**Town of Wareham, Massachusetts**

**Comprehensive Wastewater Management Plan /  
Single Environmental Impact Report**

March 2002

NOT FOR CONSTRUCTION  
**Figure 6-2**

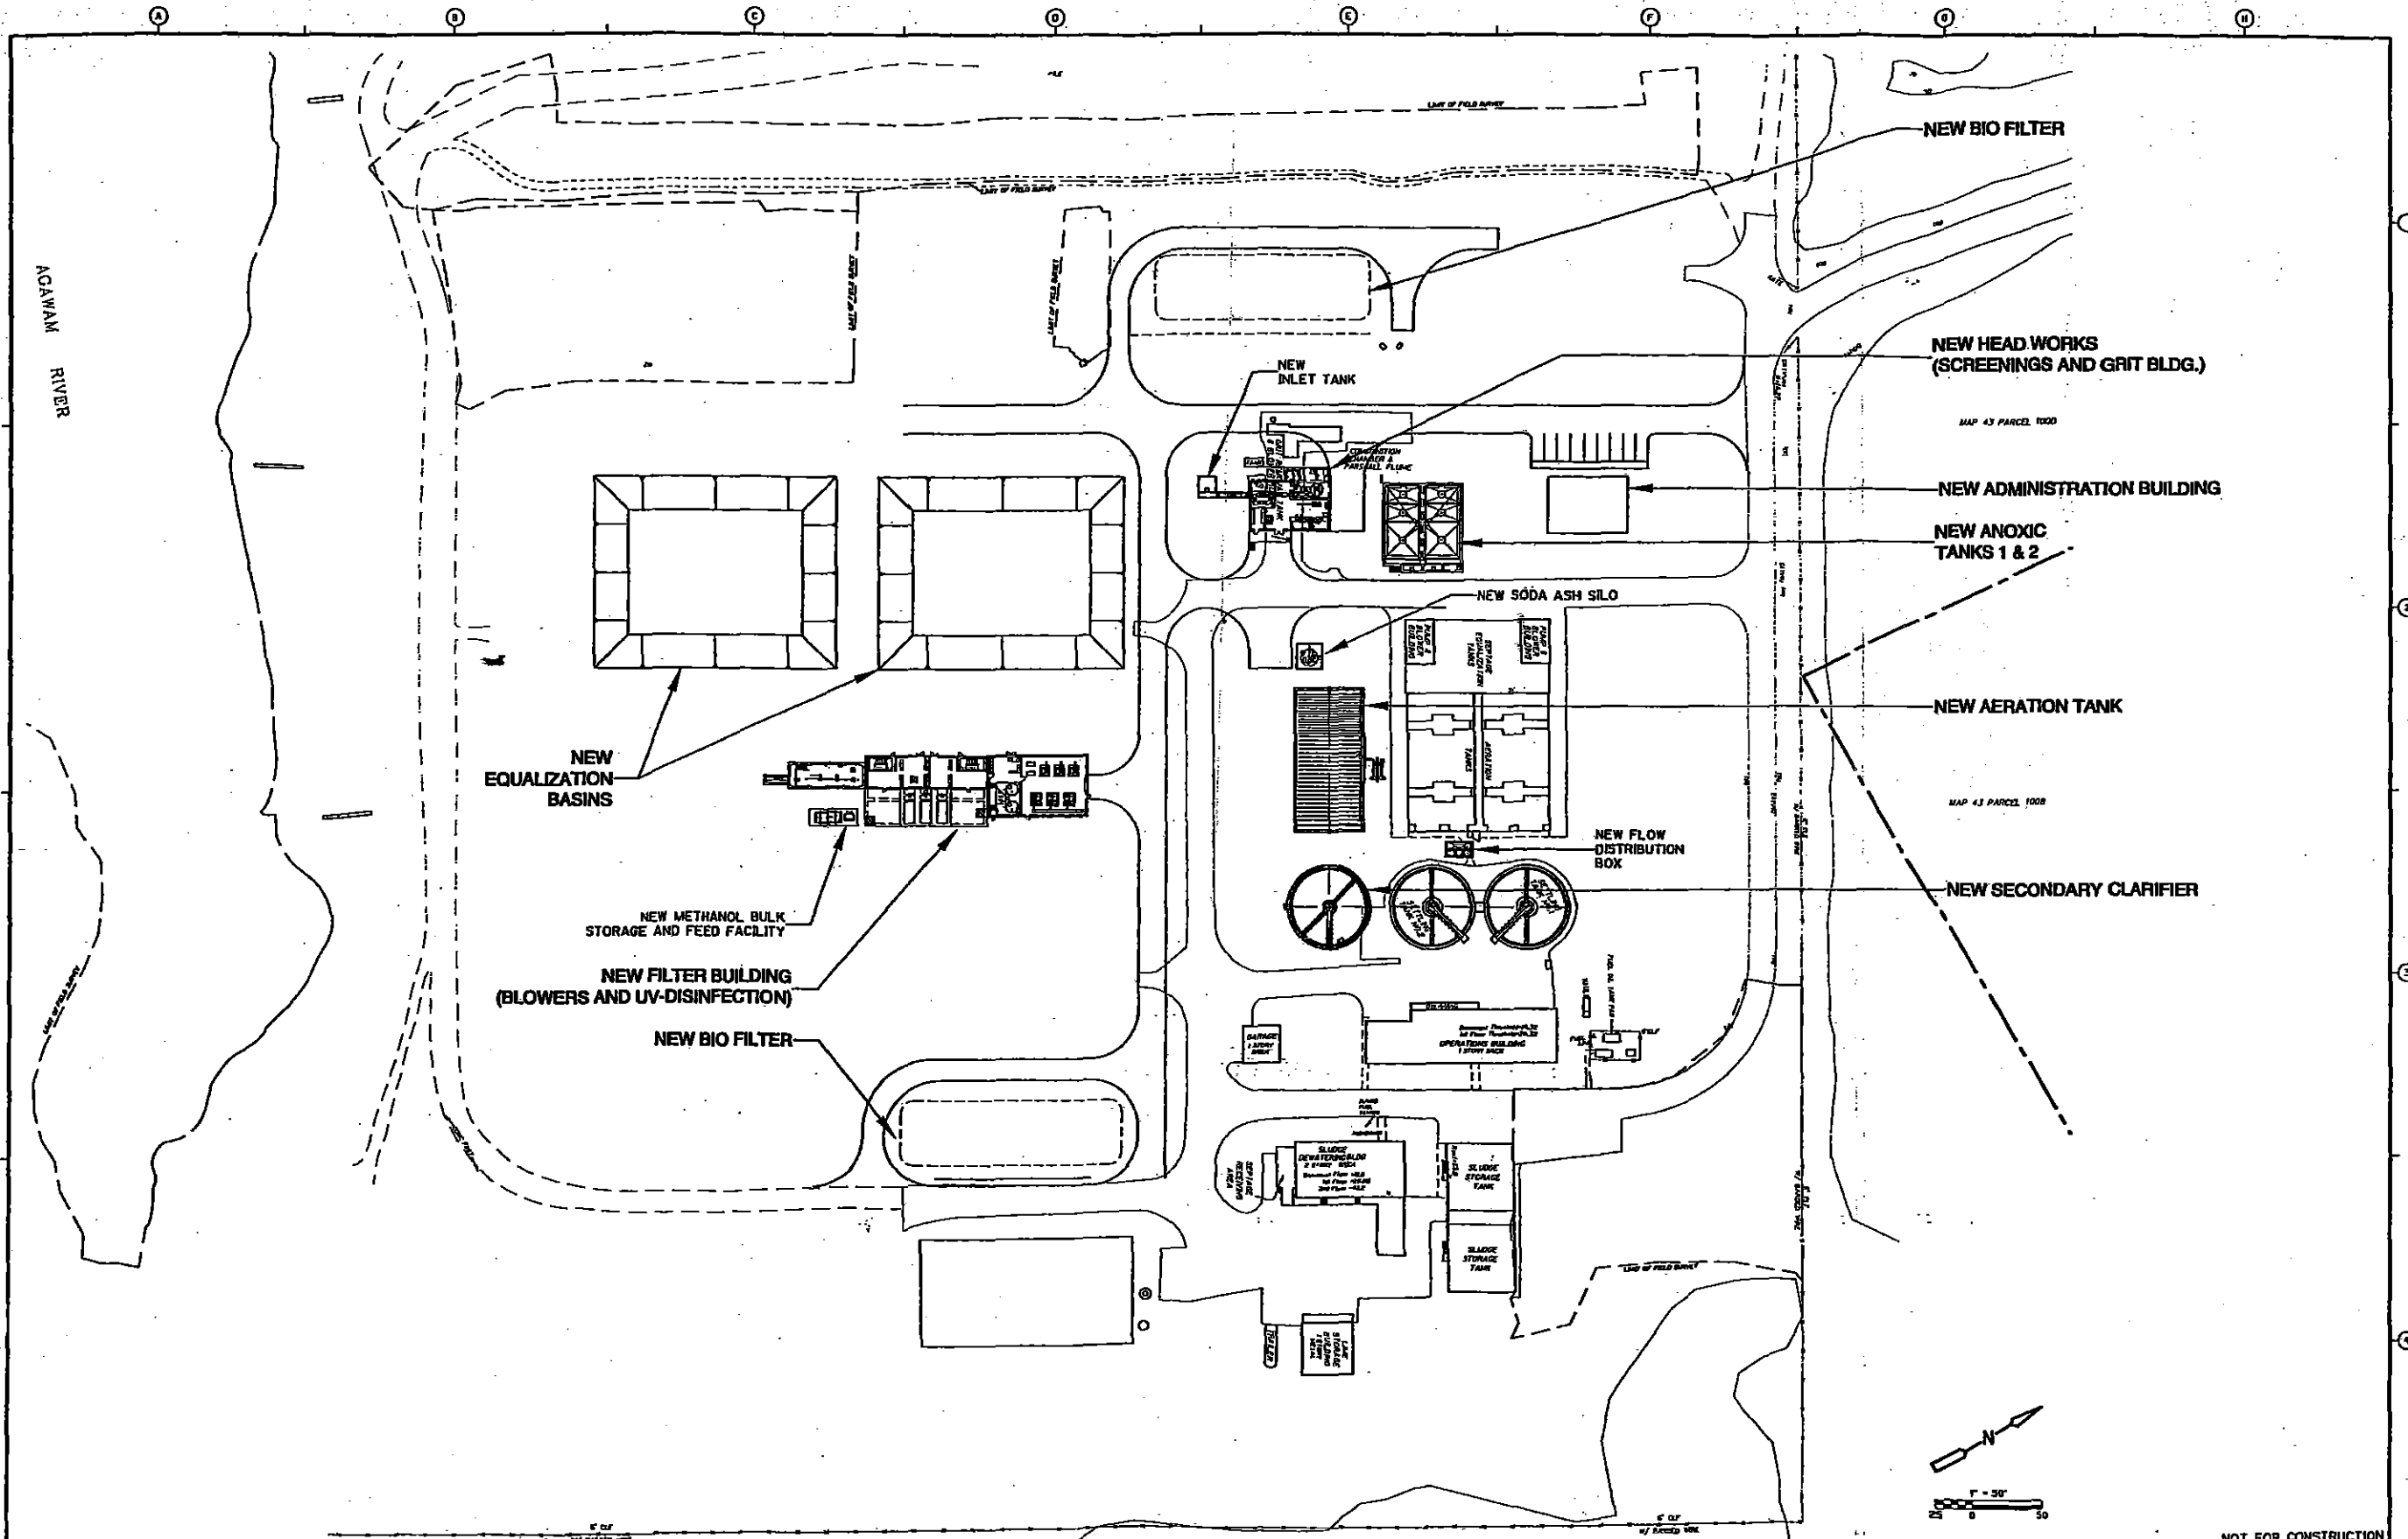
7. The proposed upgrade for the wastewater treatment plant includes two new equalization basins, as discussed on page 6-9 and shown on figure 6-2. The final wastewater management plan and EIR should address the potential for odors from these basins and how they will be dealt with.

Figure 3-26 (revised)

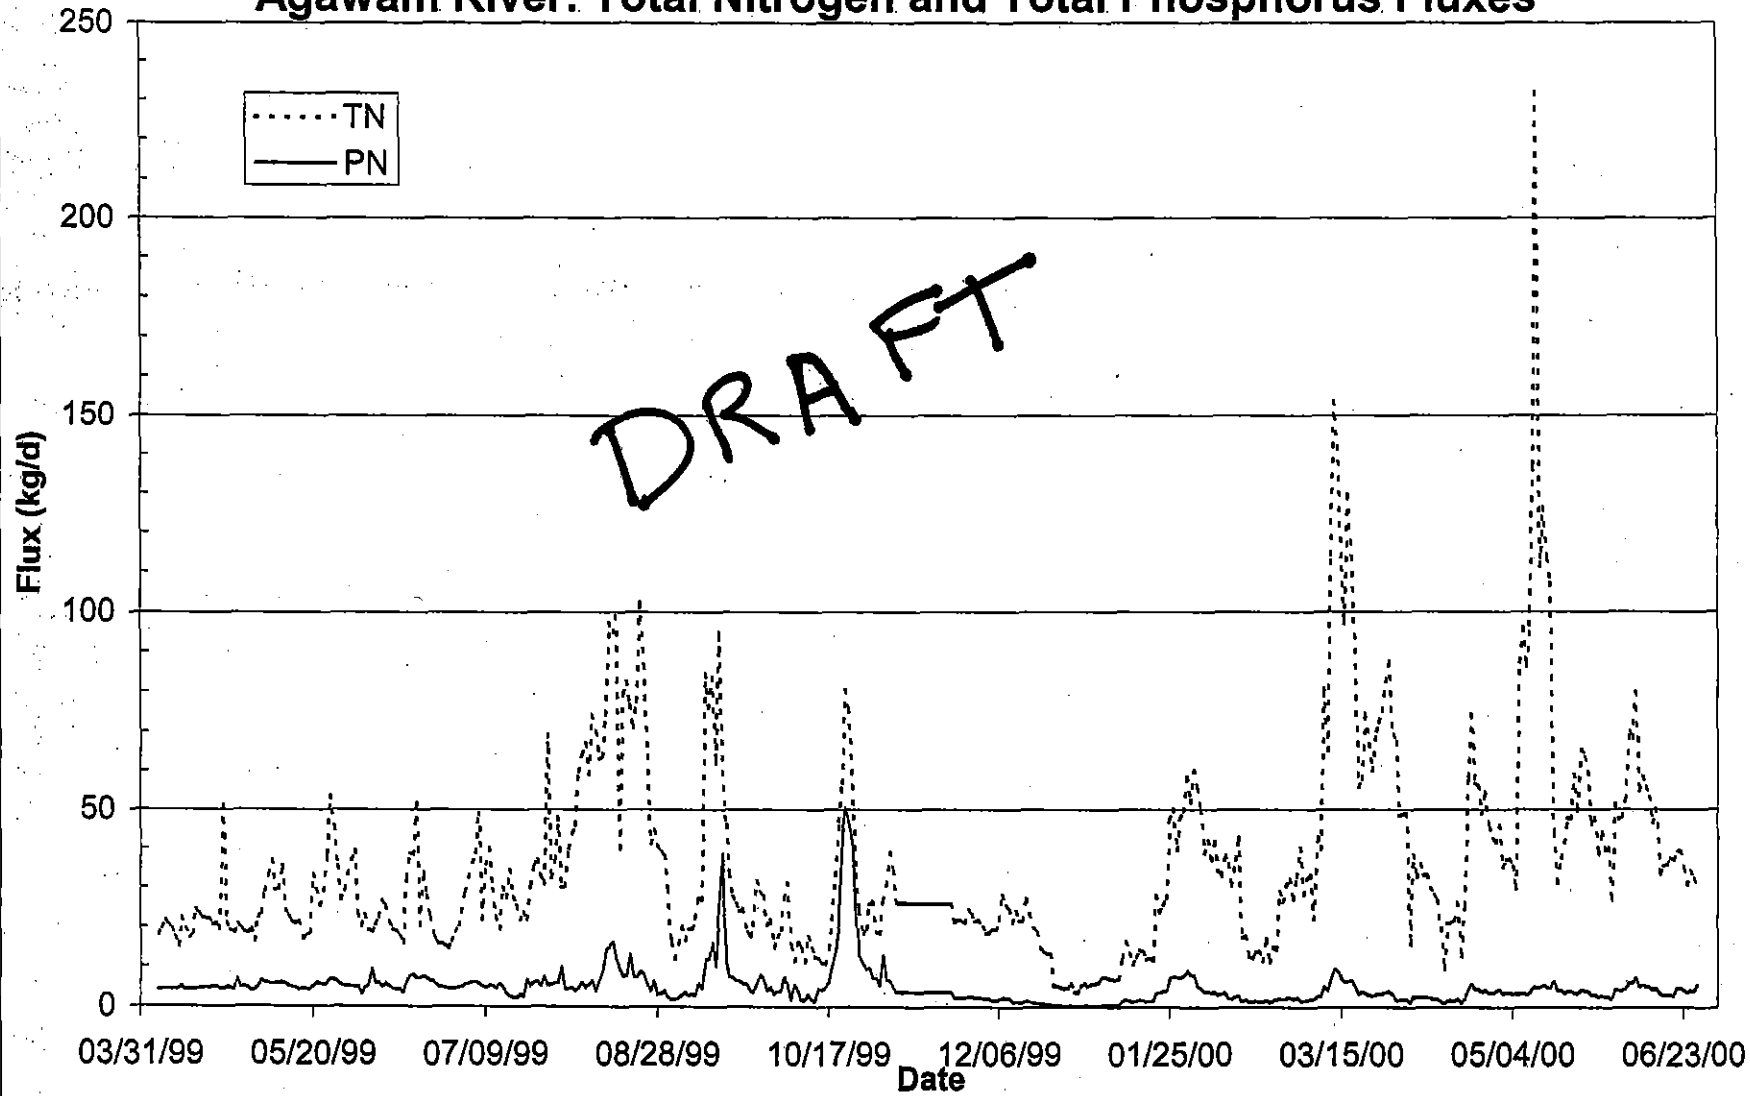
**EPA Comment #1:** The section on estimating 7Q10 flows for the Agawam River refers to flows in 1999 only dropping below the estimated 7Q10 of 17 cfs after a stop log was added upstream. Reference is also made to irregularities in gage data being matched to stop log movements. A full discussion of stop log usage needs to be included in the report. This should include all stop log locations, a description of stop log capabilities and practices, and detailed information on stop log usage in 1999. This is clearly a highly regulated river and this needs to be accounted for in any estimate of 7Q10 flows.

**CDM Response:** Although there may be many other less significant stop log stations, there are essentially only two main stop log stations located throughout the Wareham River Estuary watershed, both of which are owned and operated by the AD Makepeace Company. One of these stations is located on the Agawam River at the Route 12 bridge, just downstream of Mill Pond, while the other is located on the Wankinco River at the Tremont Nail Company along at the head of the herring run, just downstream of the Parker Mills Pond. These stations contain multiple stop logs, each measuring about 8 inches in height. Each of these stations affects the amount of freshwater that enters into the up stream end of the estuary.

In addition to the additional river flow measurements, Dr. Brian Howes also continued nutrient data collection in the Agawam and Wankinco Rivers. This work was not funded and thus the frequency of data collection was reduced. Dr. Howes' lab staff collected approximately weekly grab samples throughout this period. We have not completed analysis of these data but they suggest the calculated annualized flow and total nitrogen loads were within 10% of the values presented in the report. Annual total phosphorus loads, on the other hand, appear to have been overestimated in the report, perhaps by as much as 30%. For the period between November 1999 and March 2000, loads were computed assuming the measured nutrient concentrations were constant between sampling periods. A draft of the revised TN and TP flux data is attached as Revised Figure 3-26. We would be willing to share these data when we are done analyzing them.

**Figure 2**  
**Groundwater Level (USGS Gage #MA-WFW 51)**  
**vs**  
**Wareham WPCF Effluent TN Concentration**

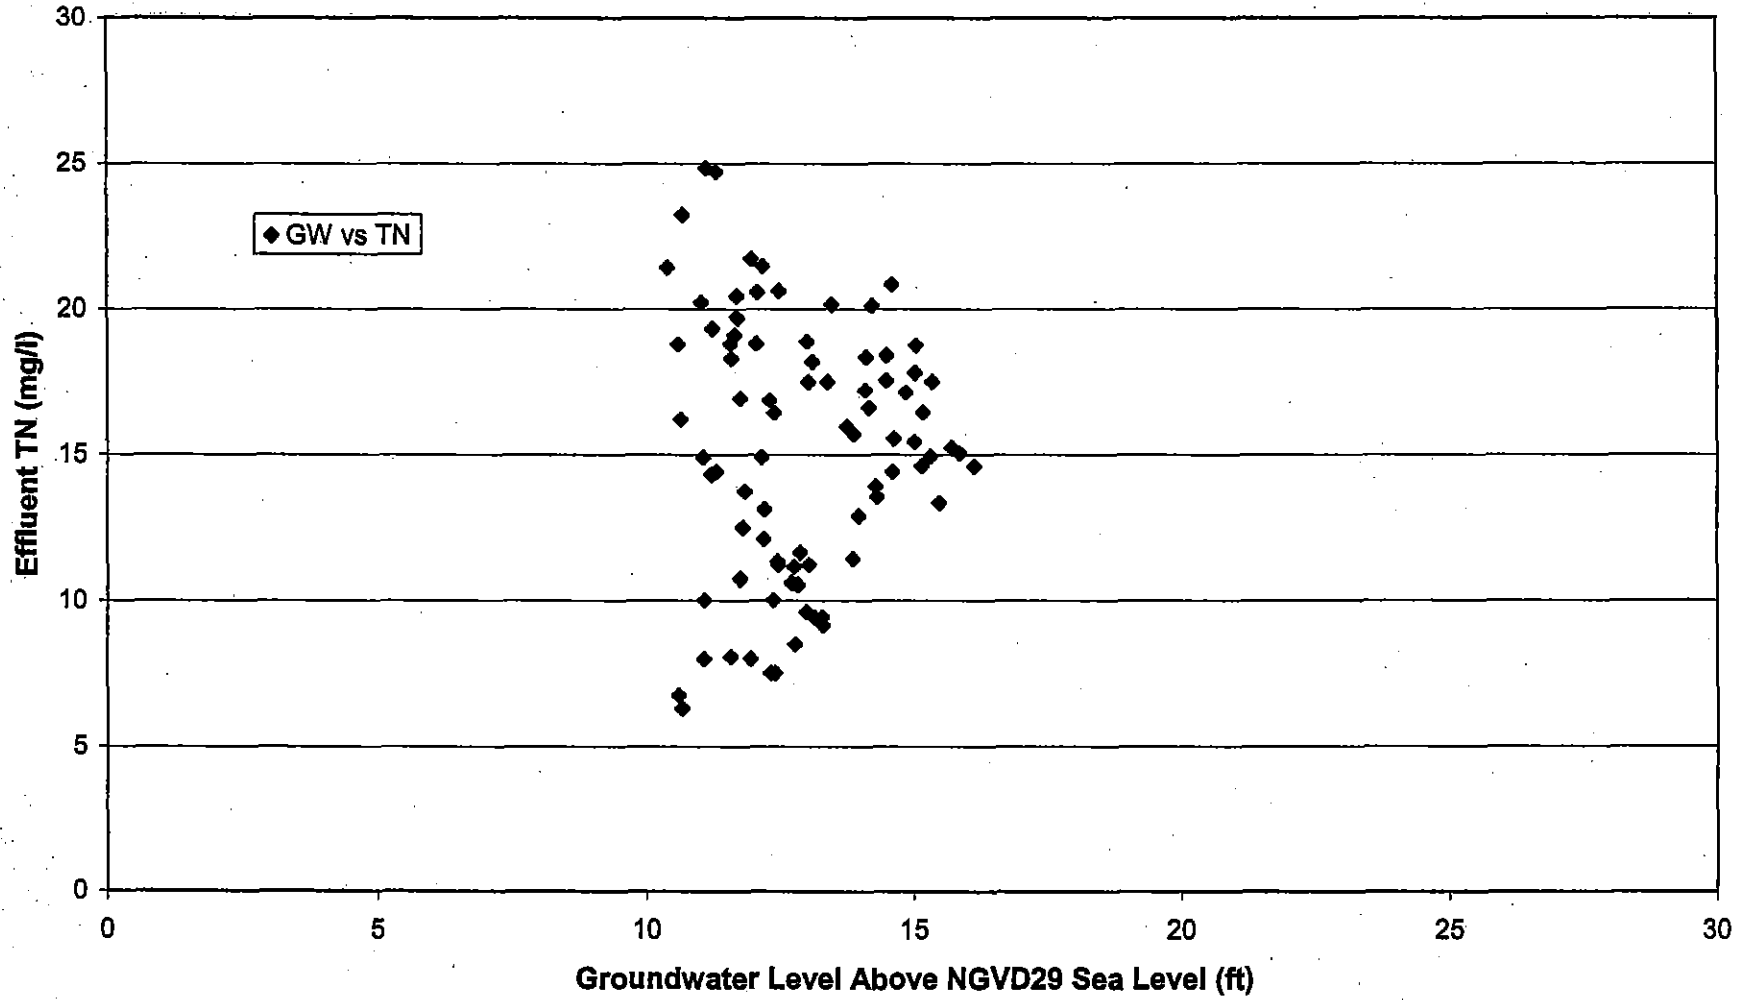
**EPA Comment #6:** The report does not include an evaluation of the effect that the 1999 drought would have on the measured nutrient loadings. Precipitation, groundwater, and stream flow levels were all significantly lower than typical years. The relative difference between these levels and typical levels should be evaluated in order to determine an appropriate correction factor for the loadings measured during a severe drought condition.

**CDM Response:** While it is true that groundwater may dilute the effluent at the Wareham WPCF, CDM does not believe that annual variations in groundwater levels correlate well to total nitrogen effluent concentrations. CDM compared USGS groundwater levels (#MA-WFW 51) to total nitrogen effluent concentrations and found very little correlation. This USGS groundwater well is located in Wareham approximately four kilometers from the WPCF as illustrated in Figure 1. The data

from this gauge (January 1994 to January 2001) are plotted versus the WPCF total nitrogen data in Figure 2. As illustrated, there is no correlation between the two data sets and furthermore when the groundwater is at its lowest (approximately 10 to 11 feet), the total effluent nitrogen concentrations vary the widest, ranging from 6.31 to 24.85 mg/l.

CDM believes that using a long-term average effluent concentration (15 mg/l) and long term influent flow rate (0.93 mgd) offers an accurate estimate of the nitrogen loading from the WPCF to the Wareham River Estuary. The variations in effluent concentration, as illustrated in Figure 3, suggest that a long-term average concentration will offer the most accurate estimate of how the WPCF is able to treat the wastewater. These variations do not correlate to seasonal trends in groundwater levels or influent flows.
